Subject : Response to DEP further queries dated 19 February 2002.

James Point Pty Ltd
 JAMES POINT PORT FACILITIES - STAGE 1
**FPA OUTER HARBOUR AND
 JPPL STAGE 1 CONCEPTS**

James Point Pty Ltd
 JAMES POINT PORT FACILITIES : STAGE 1
STAGE 1 CONCEPTUAL LAYOUT - AMENDED
MARCH 2002

Figure
1

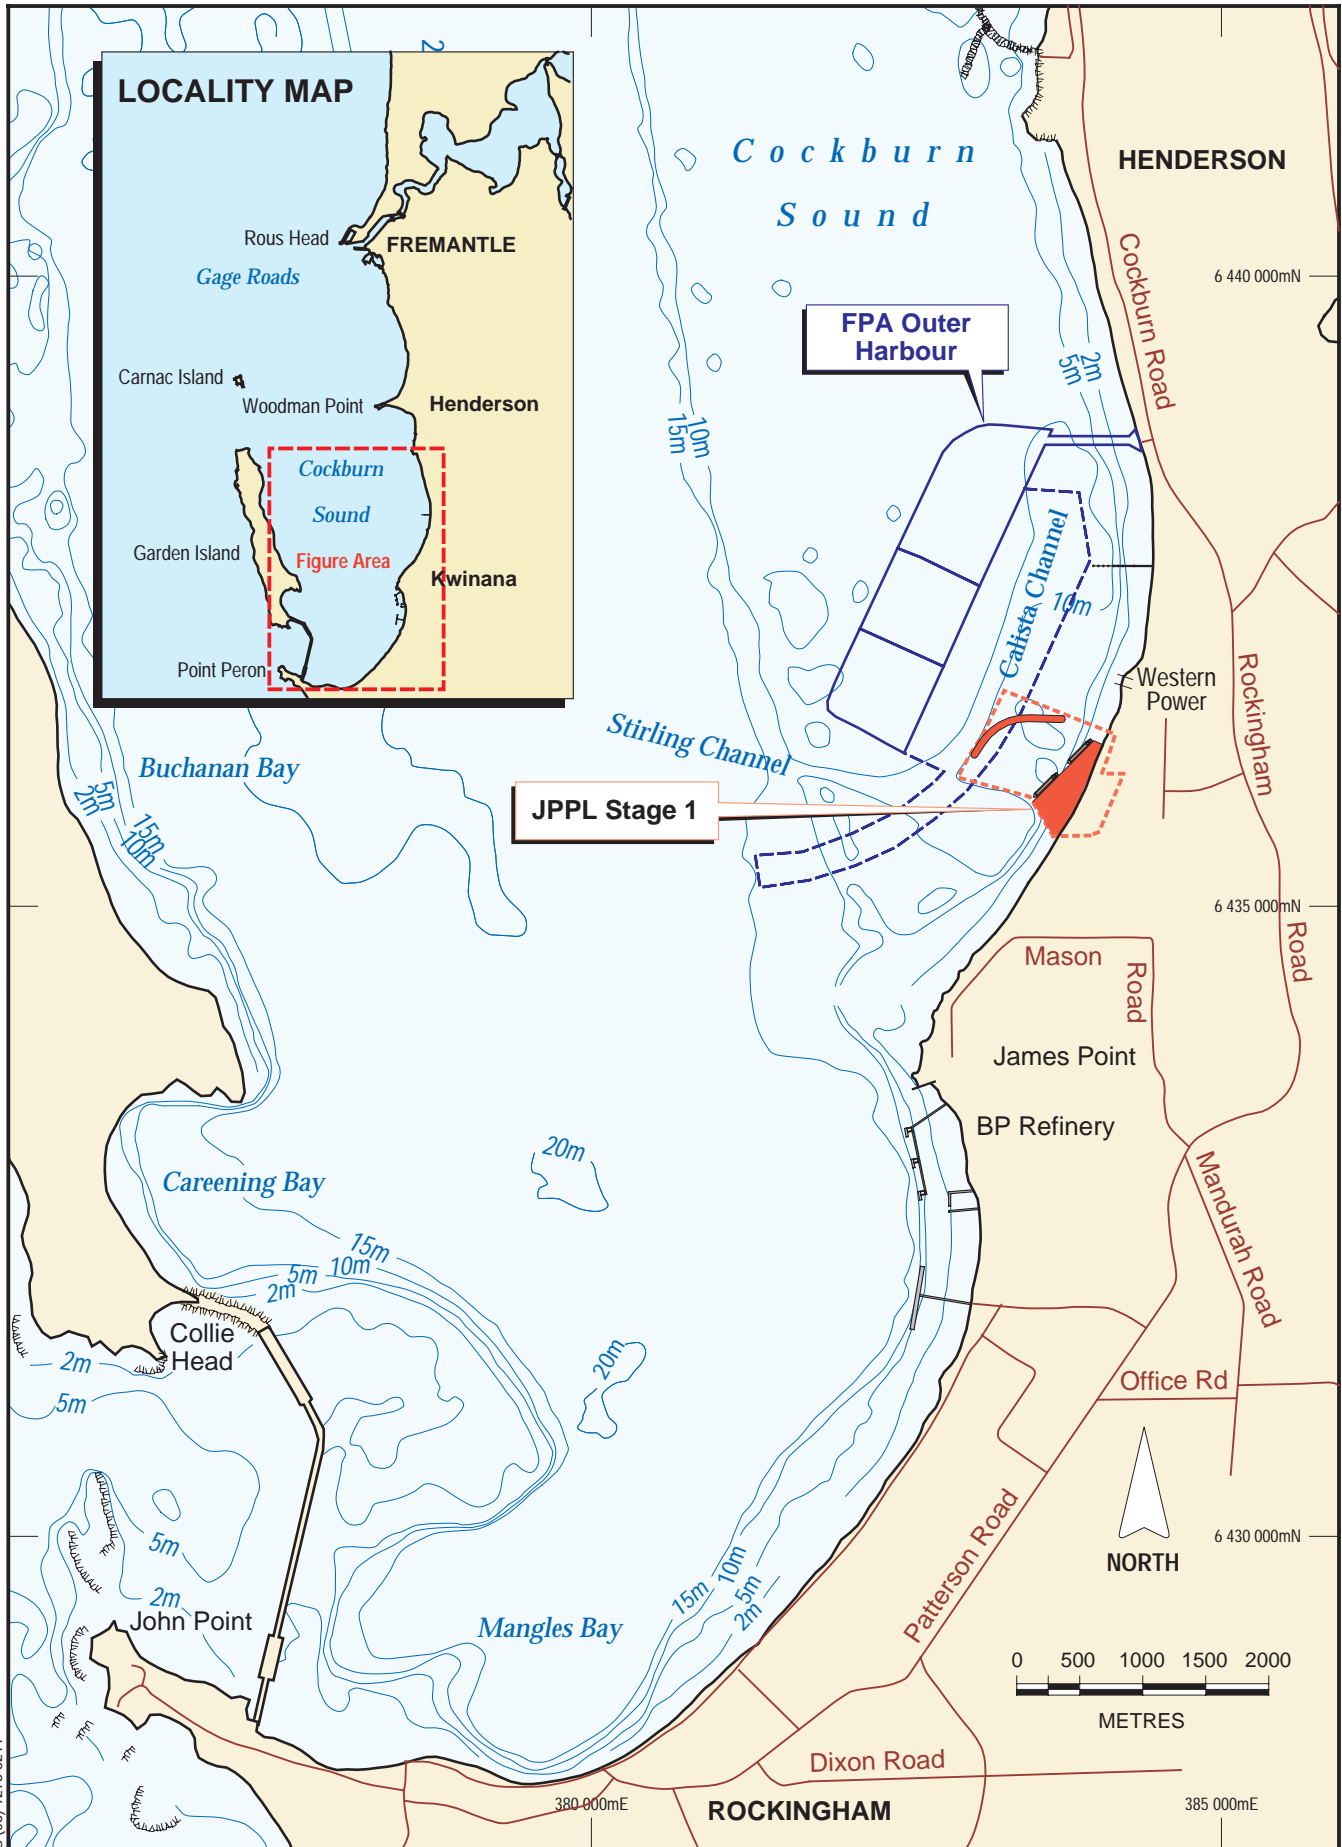
The preferred site as selected was Naval Base which is the site of the proposed James Point Port and of the proposed FPA future container port facility. Figure 1 shows the

proposed FPA outer harbour facility in comparison with the proposed James Point facility.

This view is supported by the conclusions of the Alternative Port Site Study undertaken on behalf of the WA Government in about 1988 and by the FPA's plans to establish a Container Facility at Naval Base Kwinana (offshore from the James Point proposed Port as shown in Figure 1).

Figure
2

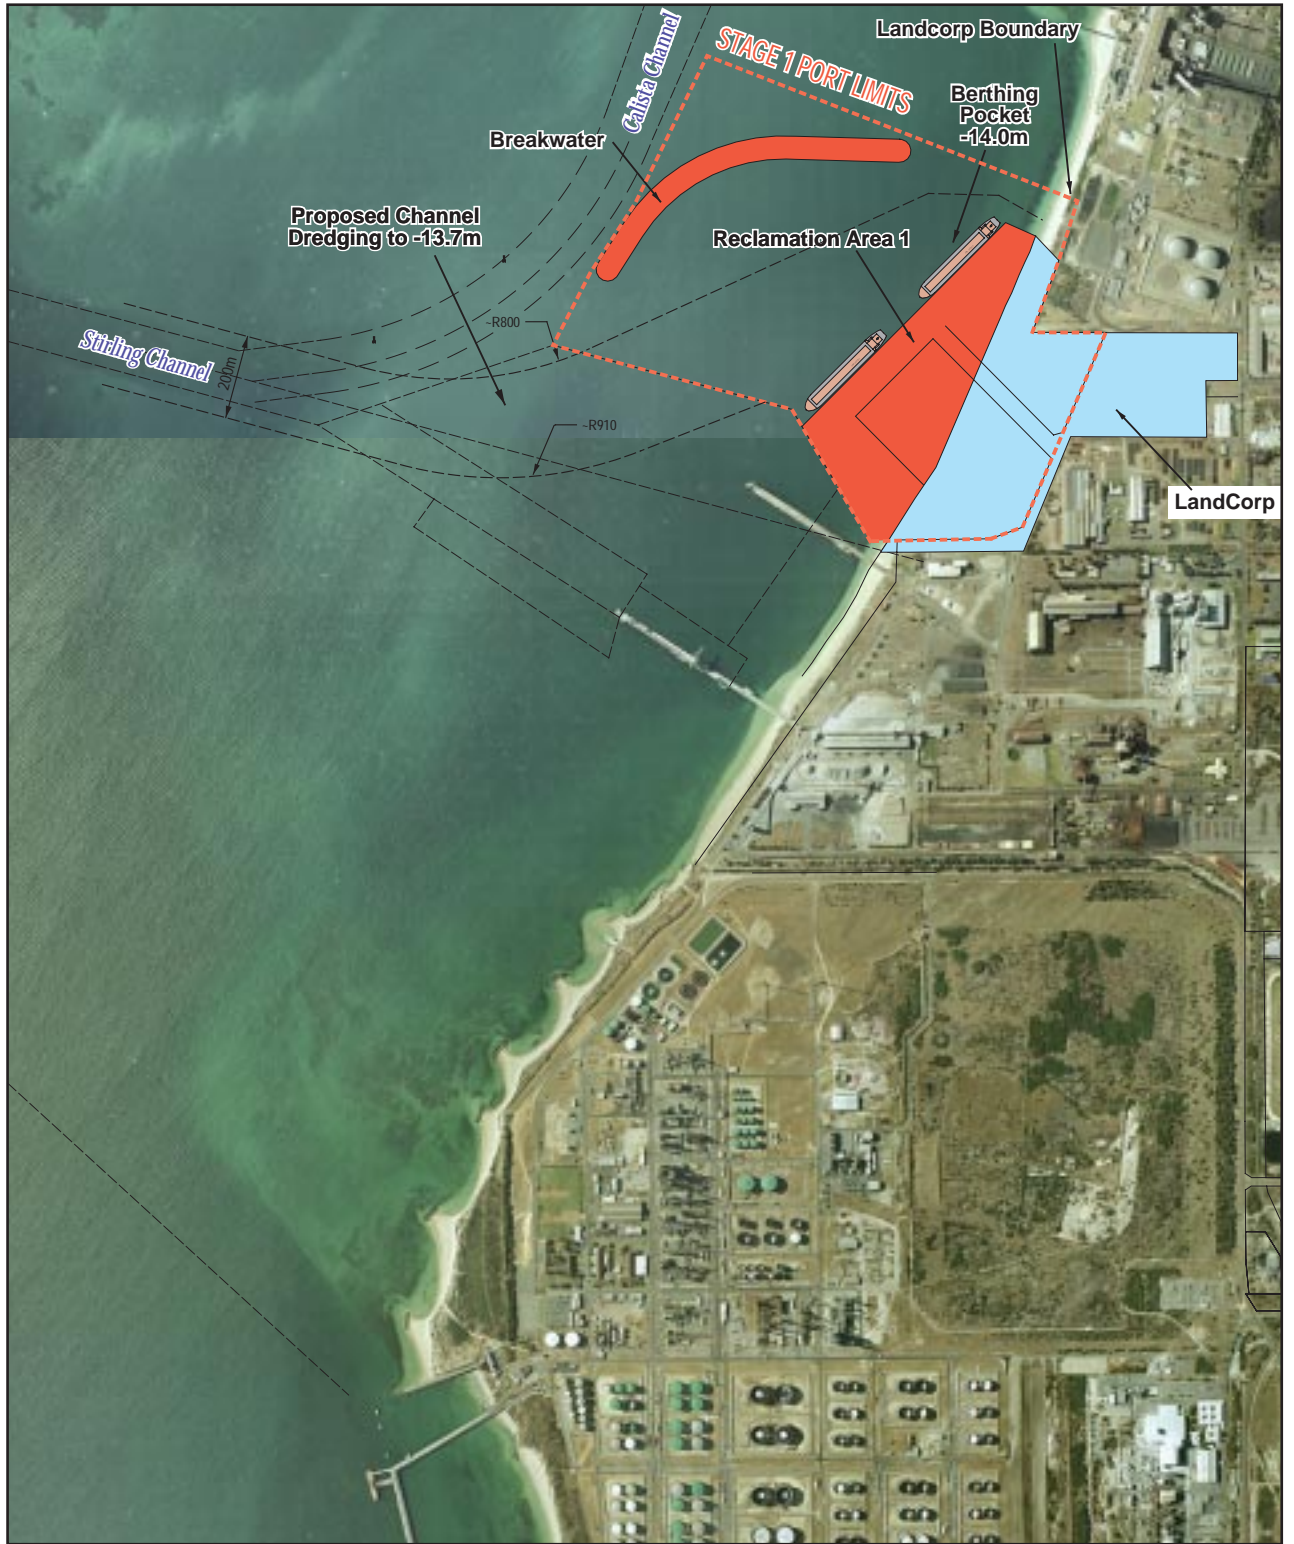
Please outline the indicative Stage One port limits. The Response to 4.1.15 suggests the port limits will be sequentially excised from Fremantle Port Authority (FPA) waters as the proposal is developed."

Figure 2 shows the revised layout which now excludes Reclamation Area 2A shown in the PER and includes the Port Limits for Stage 1. The reason for excluding Reclamation Area 2A is that at this stage the BHP jetties and navigation basin are not available to James Point Pty Ltd and there is no indication that they will become available in the near future. Therefore the Stage 1 development for which environmental approval is being sought will be limited to the development shown in Figure 2.
